BULLETIN #208

W19

INTERMITTENT GAS VALVE OPERATION

Modifying W19-11 Wirefeed PCB: (for W19-10, see next page)

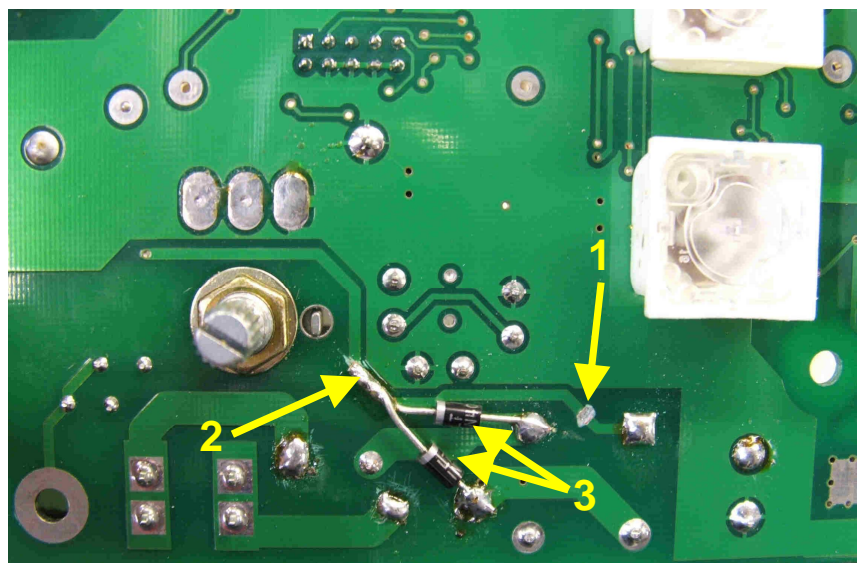
The gas valve on a W19 wirefeeder may intermittently fail to open after a period of use. This is because the voltage provided to the gas valve from the W19-10 or W19-11 wirefeed pcb is higher (from 35 to 40 volts) than specified. Because of this high voltage, the gas valve heats up and the connections in the coil may open, allowing the valve to stay shut during welding. The connection may temporarily come good again once the coil has cooled down, giving intermittent operation.

The wirefeed pcb has been modified so that the gas valve is supplied by a more suitable voltage (from 26 to 29 volts). This change has been implemented in the factory from wirefeeders starting with serial number W193A0906009002.

1. Cut track on solder side of pcb as shown.
2. Carefully prepare track for soldering – scrape just enough to remove the varnish from on top of the track without damaging the track itself.
3. Solder two diodes (1N4004 or 1N4007) in place with cathodes together as shown.
